**Subject:** Letter in opposition to ZC No. 24-15

**Date:** June 14th, 2025

I live on 10th St., sharing the block with the proposed ZC No. 24-15. I'm writing to express opposition to the 901 Monroe St development as currently proposed.

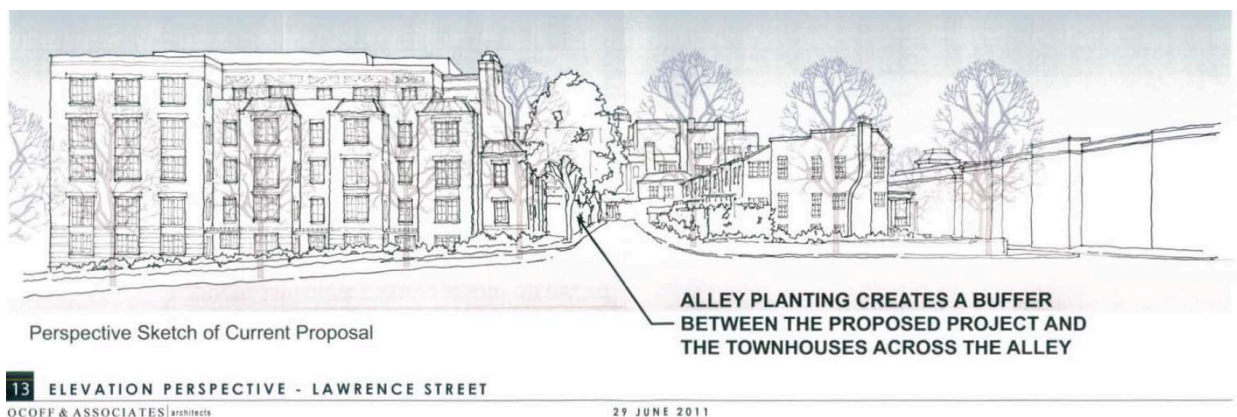
□ 901 Monroe Street should the **use existing curb cut on 9<sup>th</sup> street**; that alley entrance served the businesses and homes previously on the property (which were demolished by the developers). The **2011 design for this site used the 9th Street curb cut**; furthermore, to minimize adverse effects on the adjacent town homes.

□ **2011 design included tree buffers in the alley**—these elements should not have been abandoned in the current proposal. The ZC should require a green buffer in the alley.
